17 Dene Road Northwood, HA6 2BS

(Arboricultural Method Statement [AMS])

**London Borough of Hillingdon
Planning Condition No. 11**

Update: 09/10/2025
Ref: 101 160

**17 Dene Road N/wood
Condition 11 (Foxdell)**

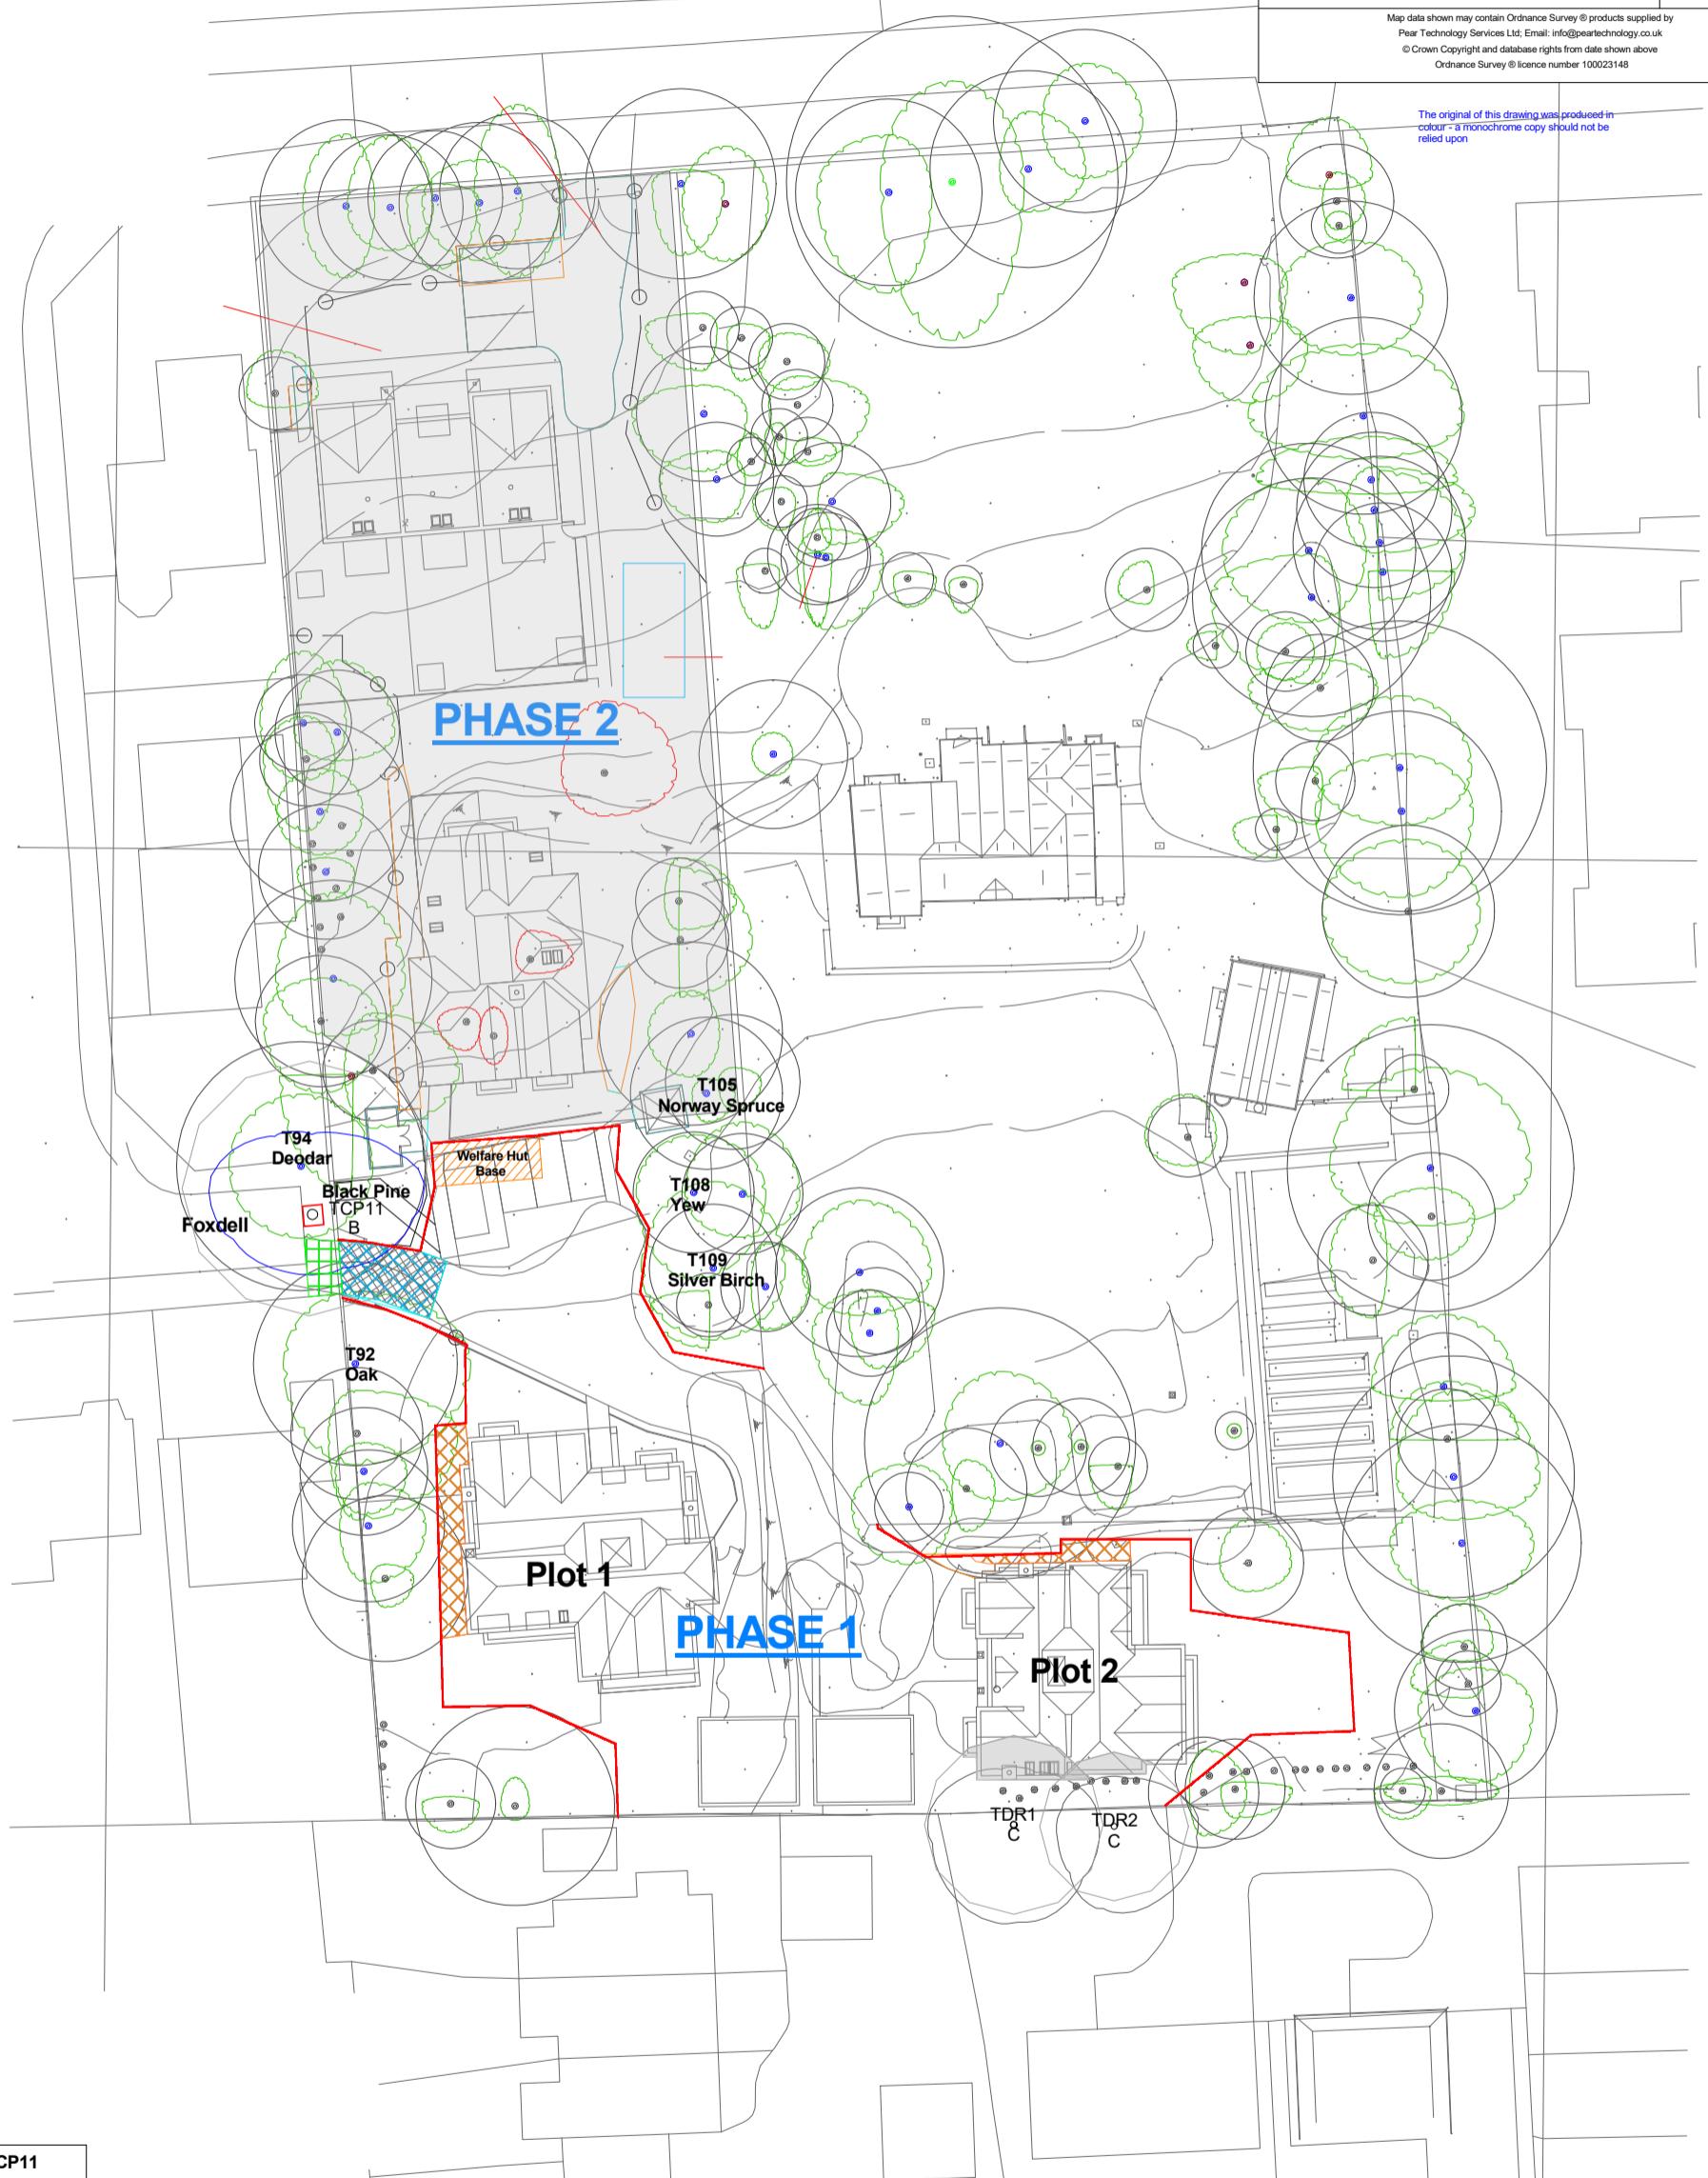
'From the plans, they are going to put a heavy-duty road-plate [green-hatched] over the footpath area to protect that section of Root Protection Area. They show this as only covering the footpath section and do not mention how they plan to deal with the kerb level change within this protection?'

AEC Ltd. comments:

Firstly, this heavy-duty road-plate was specified to protect the public-realm footway from (underlying soil) compaction from construction vehicles. Rationale: the area under this plate is within the Root Protection Area of TCP11.

Secondly, once the construction has been completed, a new drive over this public footway section will be created into the site passing by the aforementioned tree. See more details in section 4.4. of the appended AMS.

1. See measures as set out in the approved Merewood ACS Arb. Impact Assessment report.
2. Prior to any development works, install a Tree Protection Box around the trunk of TCP11. See red box plotted on the appended TPP.
3. Prior to any development works, install pinned heavy-duty road-plates on the tarmac footway next to TCP11. See green-hatched on the appended TPP.
4. Once the construction has been completed, a new drive section over the public footway will be installed into the site passing by TCP11.

4.1 The kerbstone sections - green outlined below - will be lifted and so as not to disturb or damage any underlying TC11 roots, this kerbstone removal will be carried out using only hand-tools (e.g. a pickaxe and mattock).

4.2 From this section of removed kerbing back into the site, the footway tarmac *surfacing* will be taken up using a pneumatic drill with tarmac sections removed using a mattock and rakes: to reveal the underlying Type 1 base. To match-in with the recently installed *on site* Cell Web (CW) driveway section (see 2.2.3 above) this will be sloped-up to meet this CW section and also sloped-up to match-in with the footway section on the right-hand side of TCP11 (as viewed in photo).
